Product Change Notification - ASER-23WWAI681

CCB 4235 Initial Notice: Qualification of MMT as a new final test site for selected Atmel AT27C/BV/LVxxxPU/JUxxx products.

PCN # ASER-23WWAI681
CCB 4235_Pre and Post Change Summary

QUALIFICATION PLAN SUMMARY

PLCC 32 CARRIER TAPE

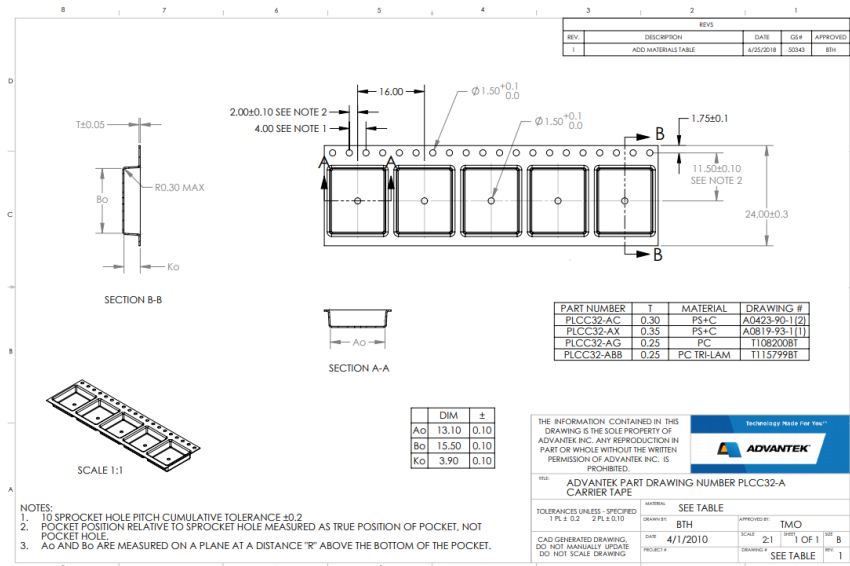
Supplier	Mfg. Part No.	W (mm.) ±0.3 or Specific	P (mm.) ±0.1 or Specific	A ₀ ±0.1 or Specific	B ₀ ±0.1 or Specific	K ₀ ±0.1 or Specific	Thickness
Advantek	PLCC32-AC170.M1	24	16	13.10/-0.1	15.50+/-0.1	3.90+/-0.10	0.30 +/-0.05

PLCC 44 CARRIER TAPE

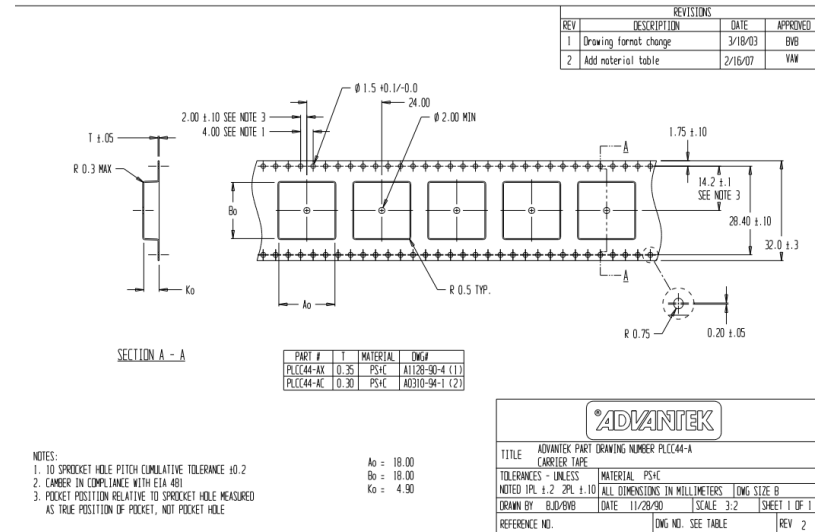
Supplier	Mfg. Part No.	W (mm.) ±0.3 or Specific	P (mm.) ±0.1 or Specific	A ₀ ±0.1 or Specific	B ₀ ±0.1 or Specific	K ₀ ±0.1 or Specific	Thickness
Advantek	PLCC44-AC88.0R5	32	24	18+/-0.1	18+/-0.1	4.9+/-0.1	0.30 +/-0.05

PLCC 32 COVER TAPE (Width: 24mm)

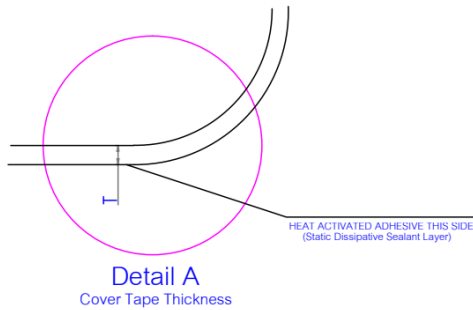
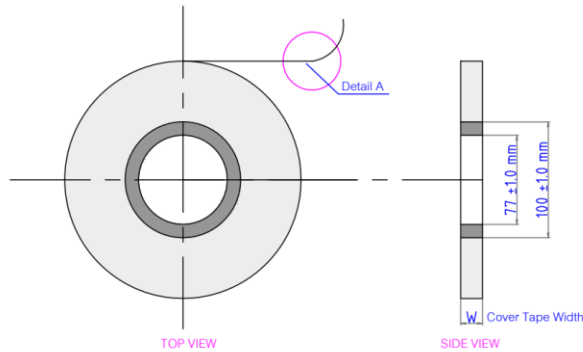
Carrier Width	Supplier	MCHP P/N	Supplier Part	Width "W" (mm)	Thickness (mm)	Sealing Mythology
24mm	Sumitomo	22102002	CSL-Z7302	21.0 +/- 0.1	0.050 ±0.010	Heat Sealing

PLCC 44 COVER TAPE (Width: 32mm)

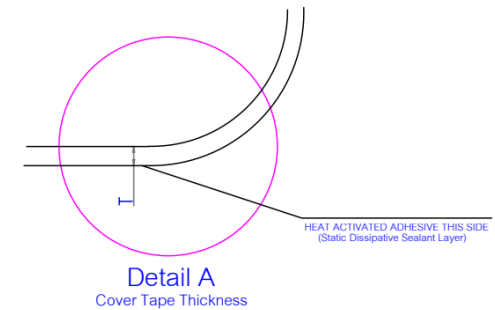
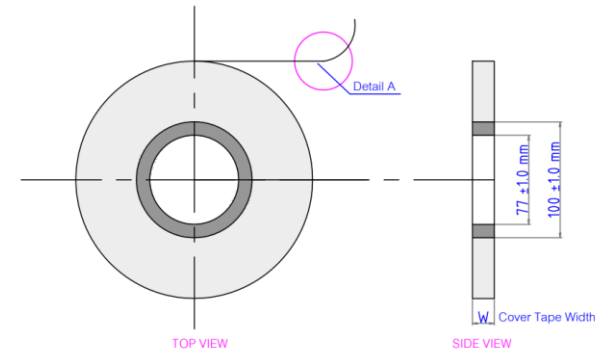
Carrier Width	Supplier	MCHP P/N	Supplier Part	Width "W" (mm)	Thickness (mm)	Sealing Mythology
32mm	Sumitomo	22104401	CSL-Z7302	25.5 +/- 0.1	0.050 ±0.010	Heat Sealing

PLCC 32L

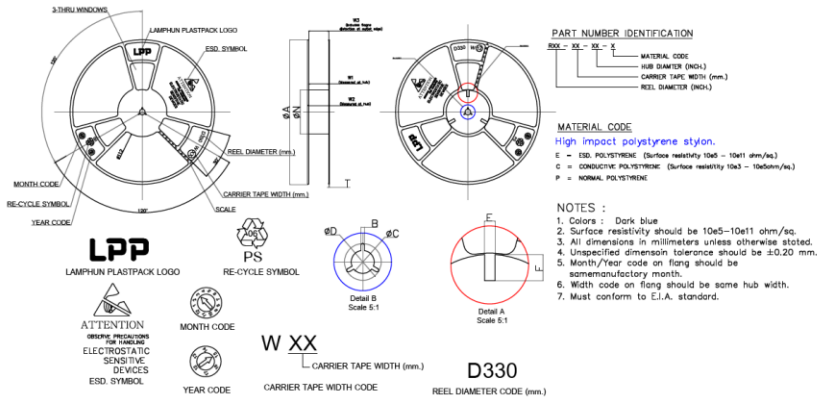
Width	MCHP P/N	Supplier Part	Hub	Color
24mm	23000024	R13-24-04-E	4inch (100mm)	Dark Blue

Description	MPHIL	MMT
Color	White	Dark blue
Diameter	329.99 +/- 1.0	330 +/- 2.0
Hub	100	100 +/- 2.0
Width	25.5 +/- 0.5	24.4 +/- 2.0

PLCC 44L

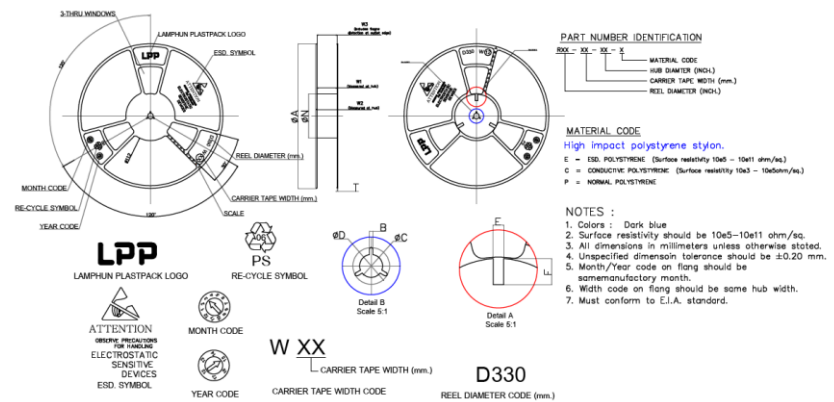
Width	MCHP P/N	Supplier Part	Hub	Color
32mm	23000023	R13-32-04-E	4inch (100mm)	Dark Blue

Description	MPHIL	MMT
Color	White	Dark blue
Diameter	329.99 +/- 1.0	330 +/- 2.0
Hub	100	100 +/- 2.0
Width	33 +/- 0.5	32.4 +/- 2.0
